Slingsby Sailplanes Ltd., Kirbymoorside, York.

Technical Instruction No. 11.

Skylark Mod. No. 99

Installation of Canopy Catch 50-1-110 On Skylark 2 & 3 Aircraft

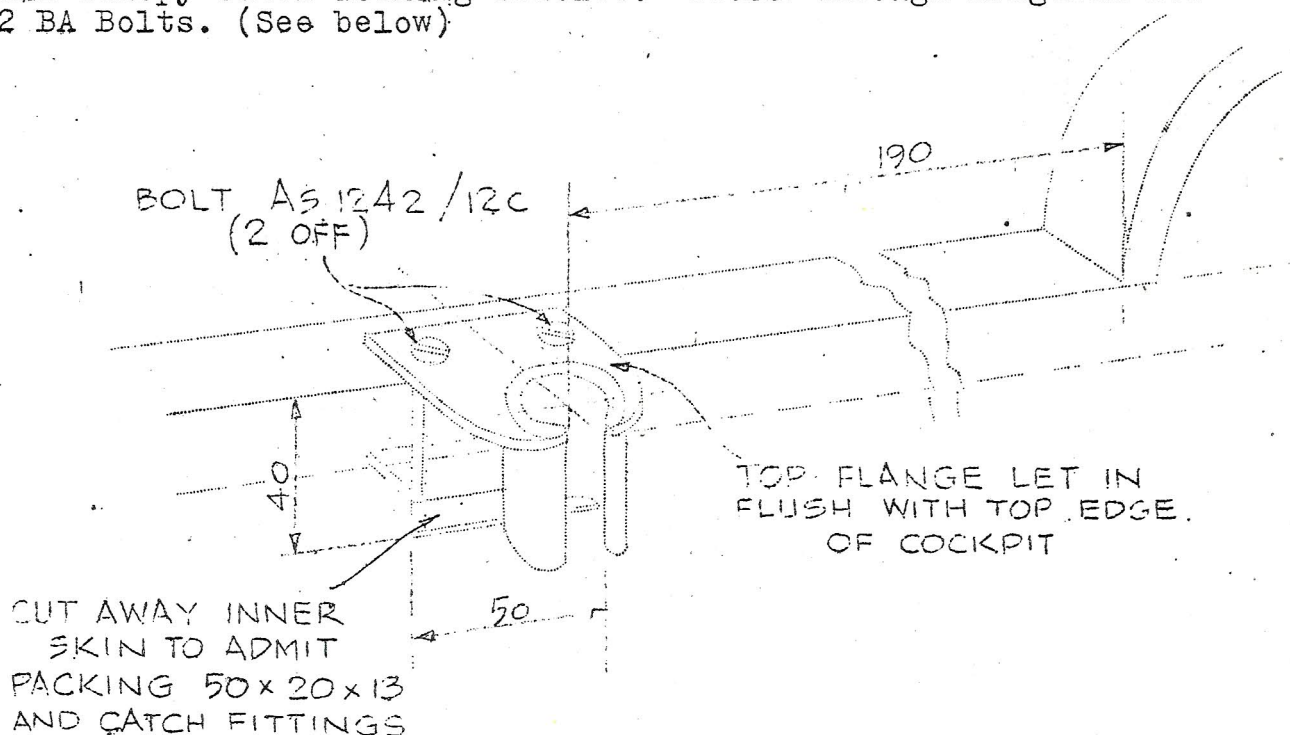
1. Remove the existing canopy catch and packing pieces from the port side of the cockpit and canopy.
2. Fit spruce packing member for canopy catch operating mechanism on canopy lower member as shown below

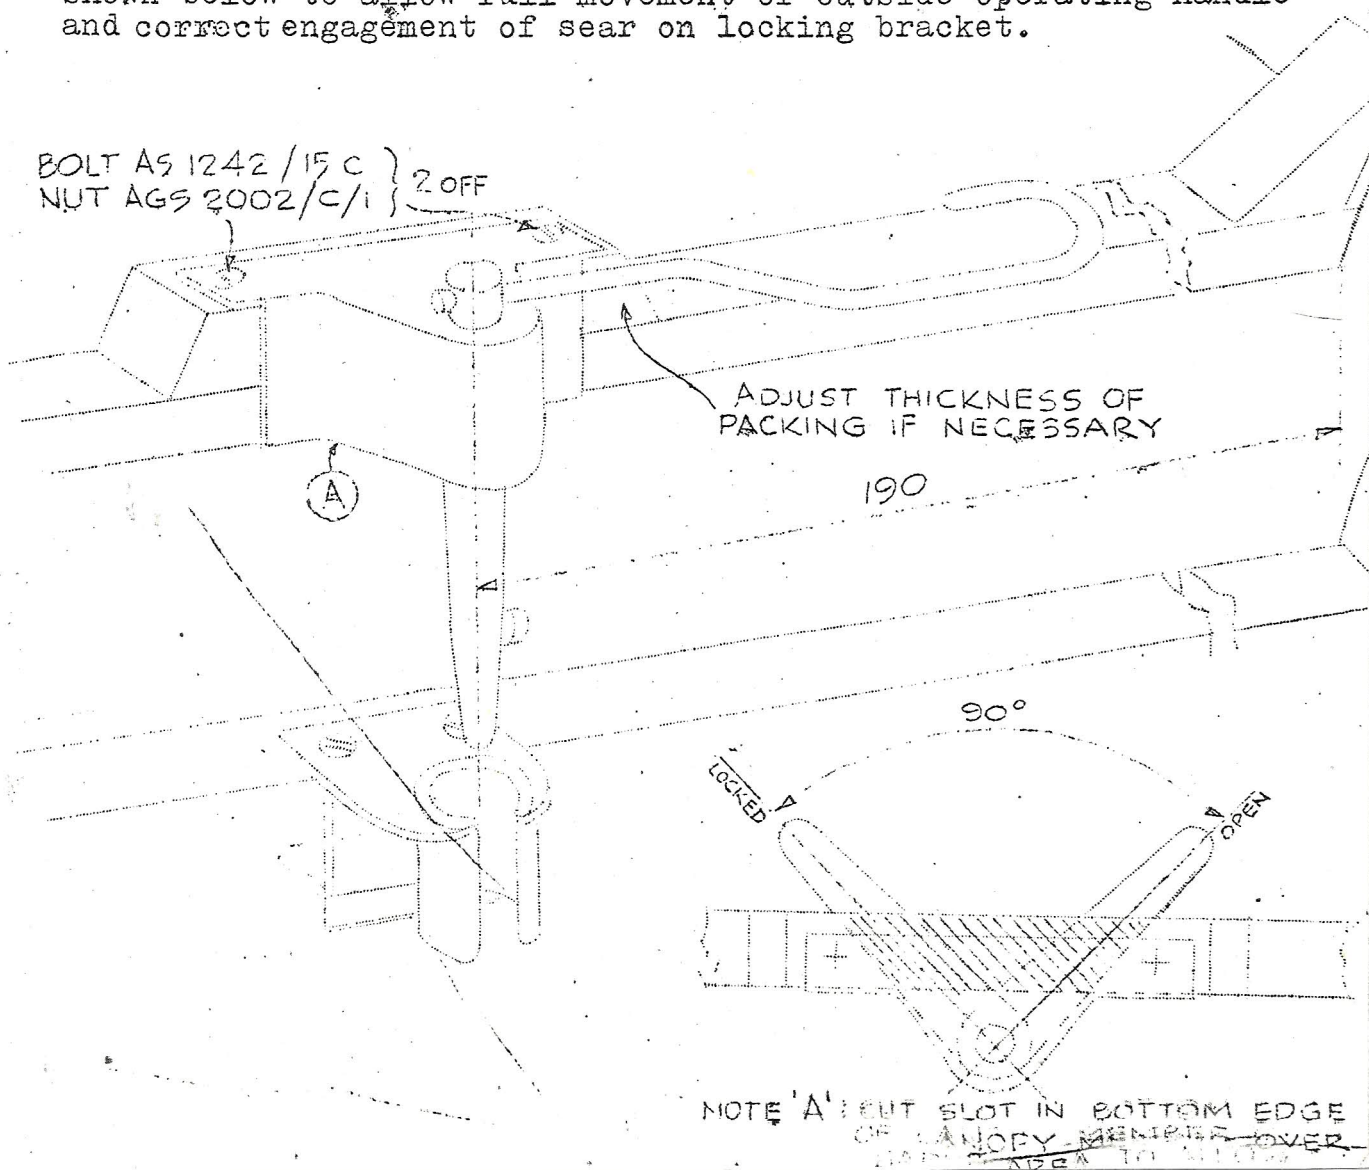
3. Cut away inner skin in cockpit to admit packing 50 x 20 x 13 and canopy catch locking bracket. Drill through longeron for 2 BA Bolts. (See below)

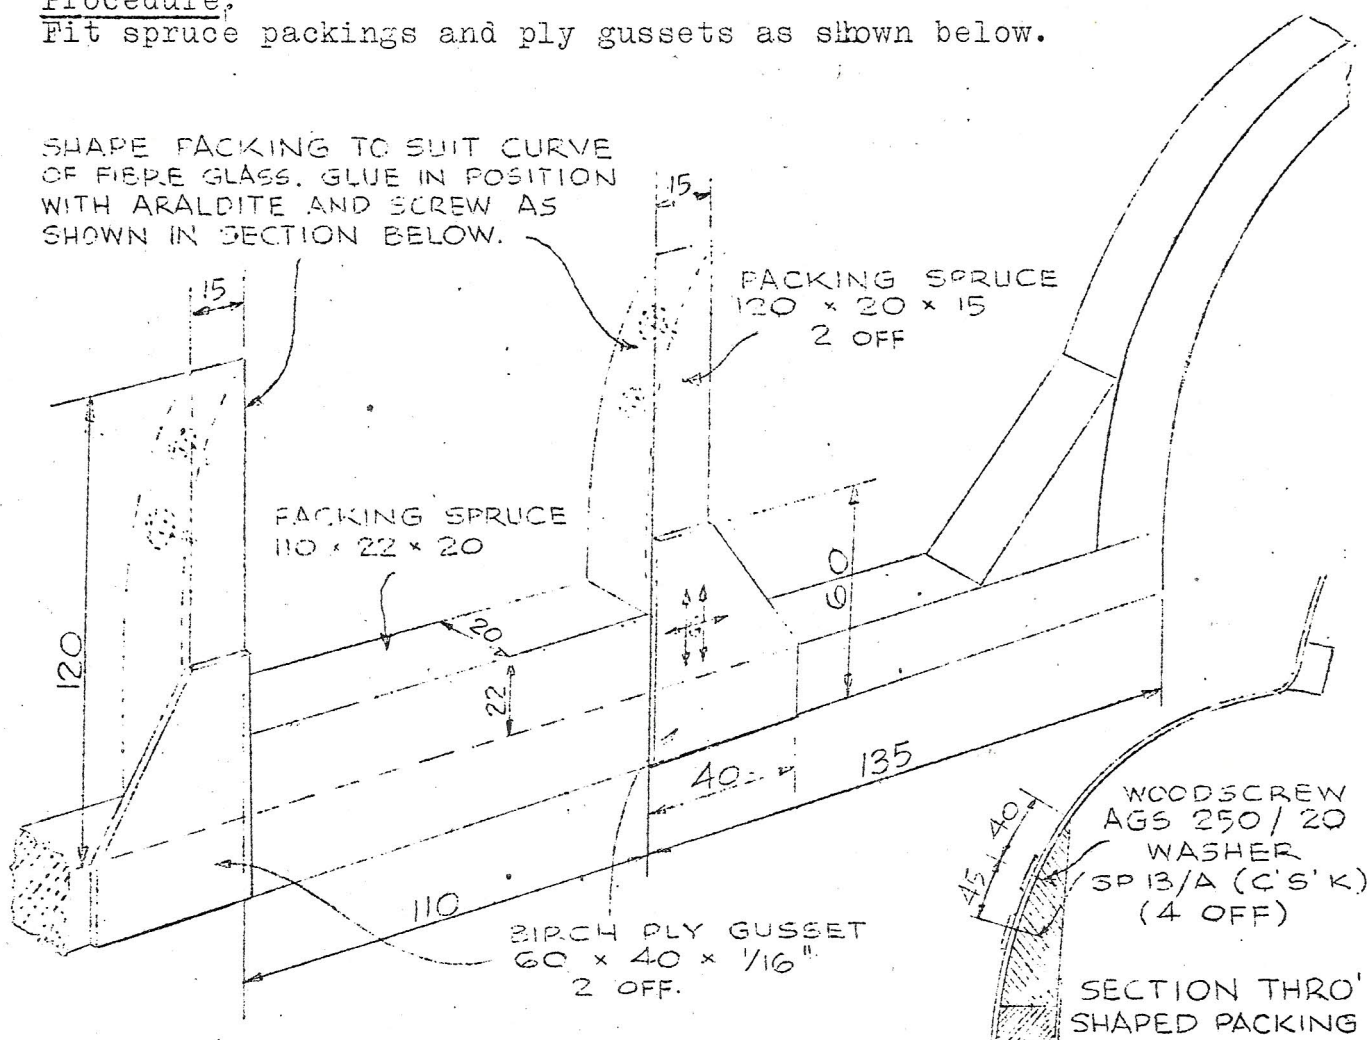
Addendum 1 - Affects aircraft with moulded fibreglass canopy's, and is intended to reduce the flexibility of the fibreglass caused by operation of the new type 50-1-110 canopy catch.

Fit spruce packings and ply gussets as shown below.
